Agenda Item 3
1425 Telegraph Road
Continued Consideration of a New House on a Vacant Lot

1425 Telegraph Road

Continued consideration of plans for a new two-story single-family residence and the associated hardscape and landscape on a vacant lot.

Summary of Request

1138 S. RIDGE ROAD, LAKE FOREST
 LAKE FOREST, ILLINOIS

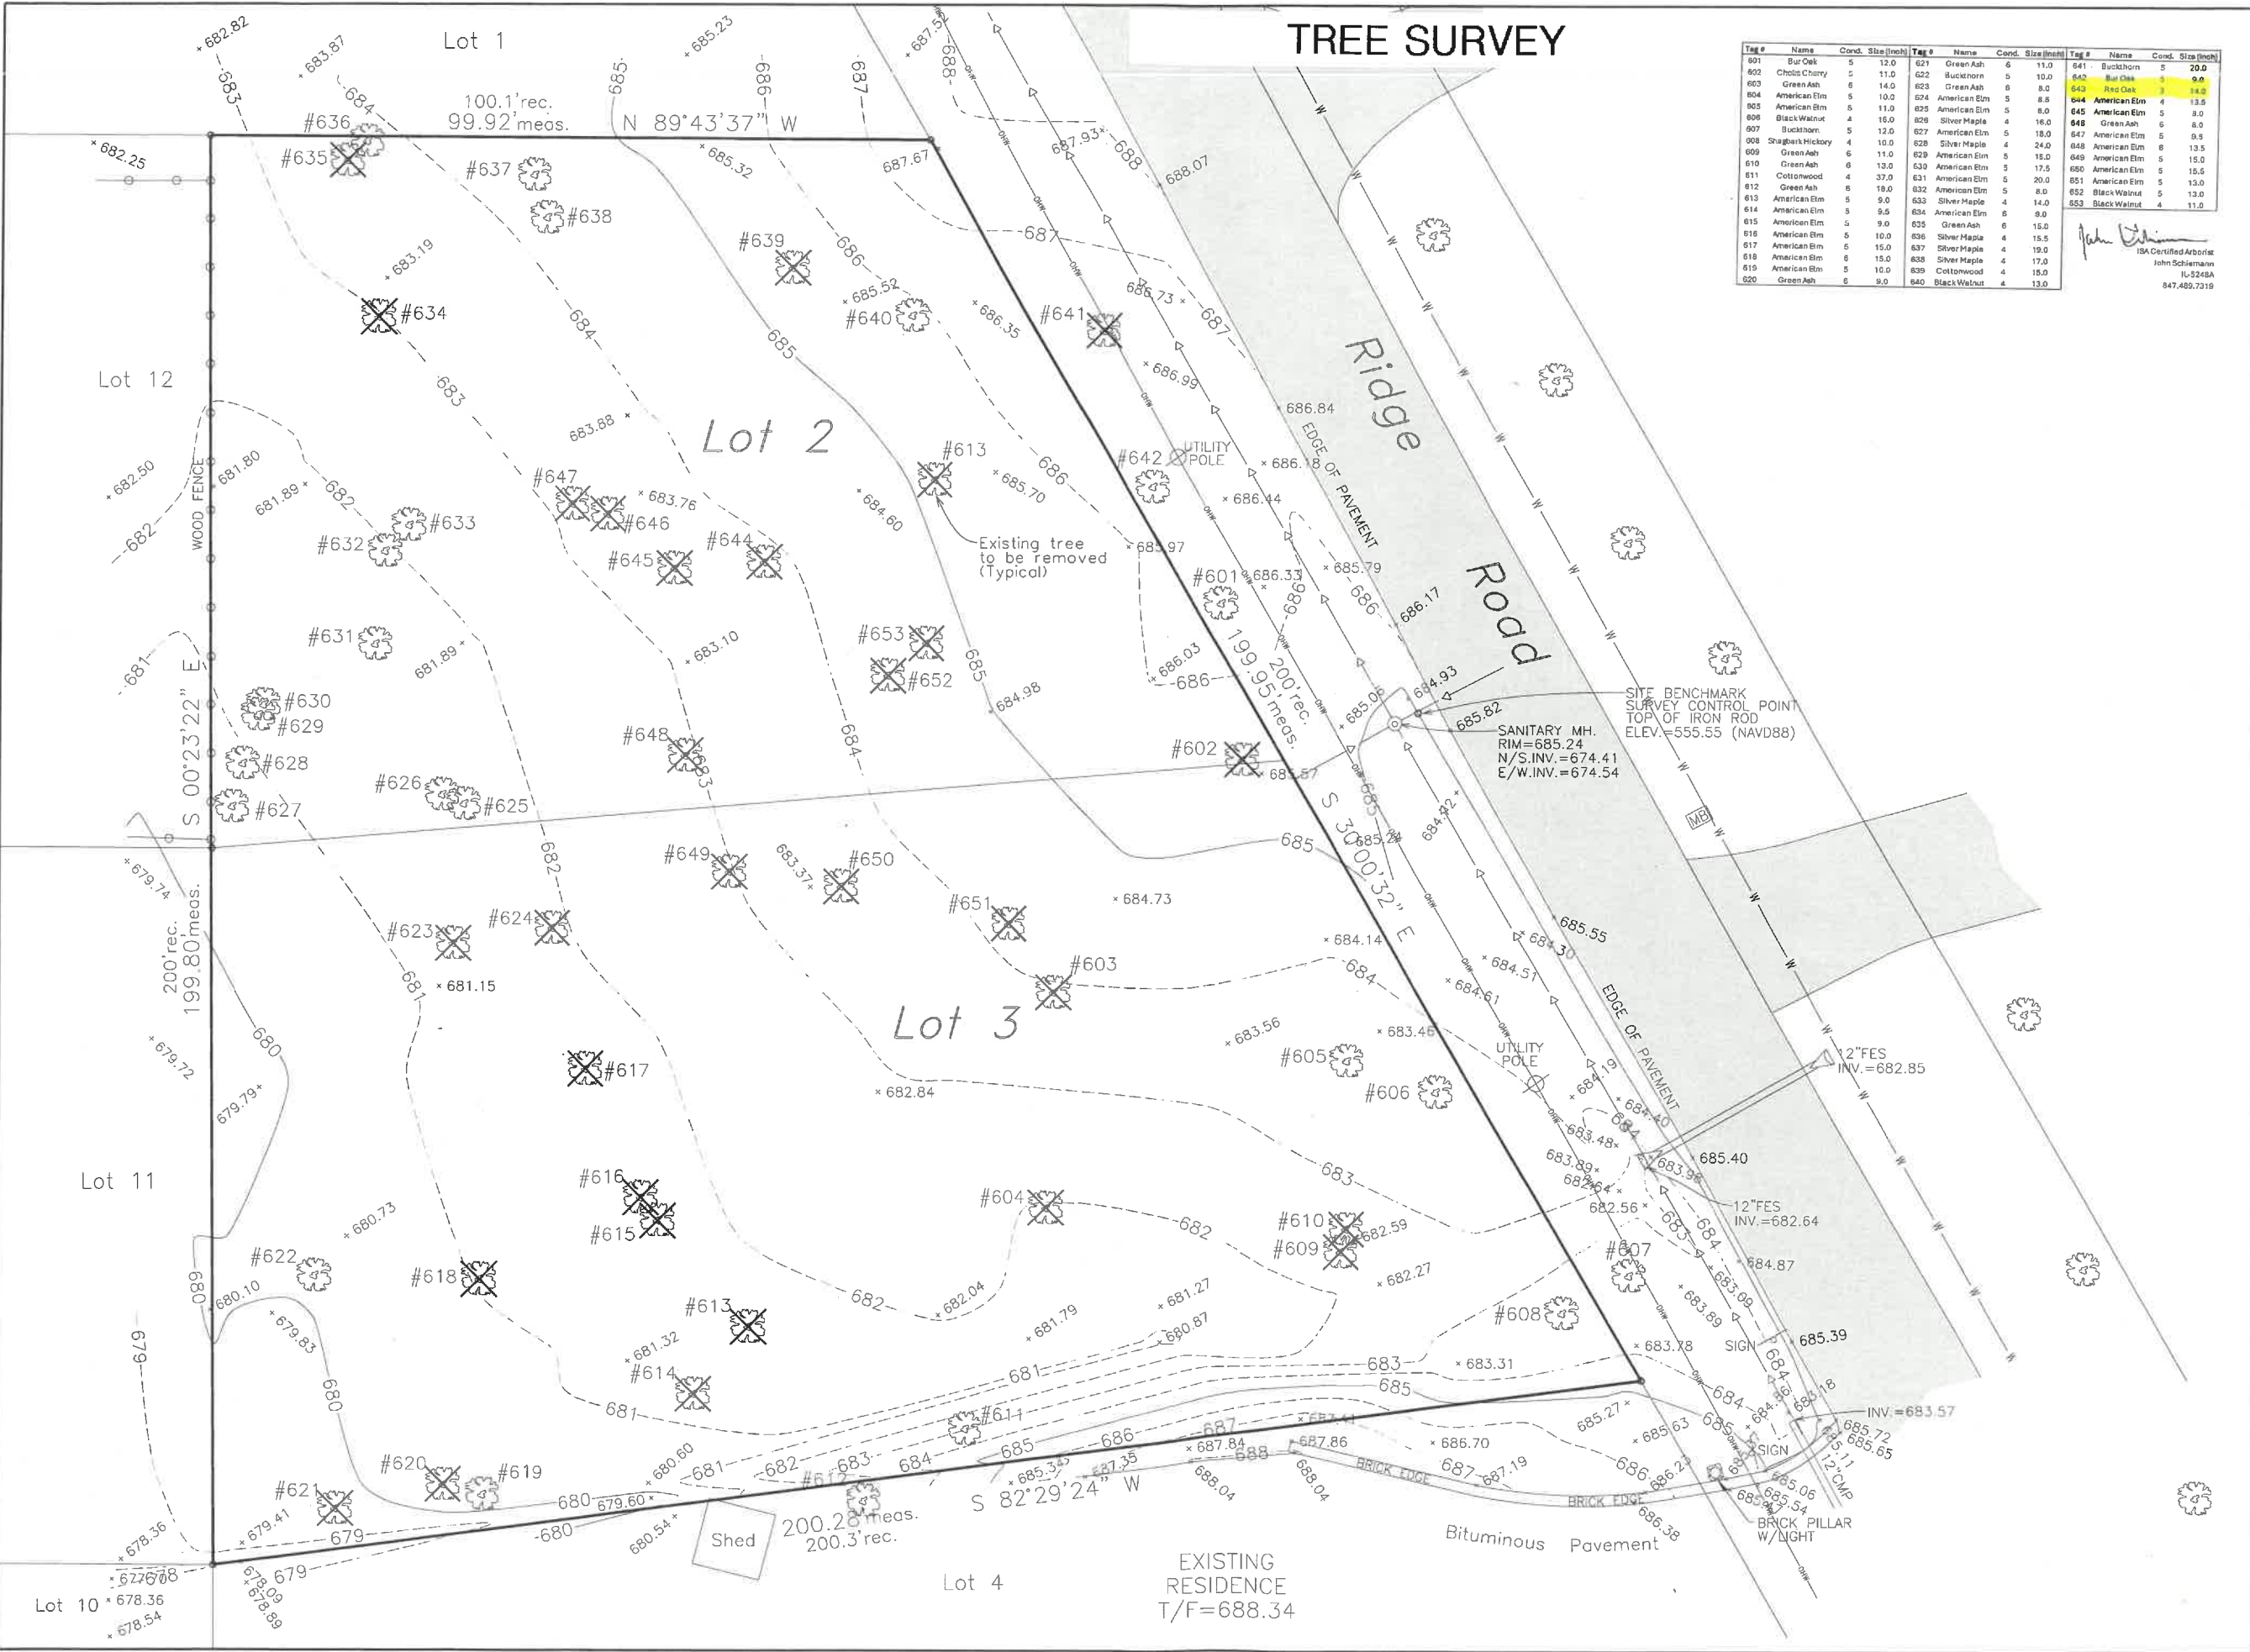
According to the tree removal plan, only one tree in good health (#643) will be removed. The plan should be amended to indicate the location of this tree. The tree will require 24 replacement inches. An updated tree survey is required showing the location of all those intended to remain and those intended for removal.
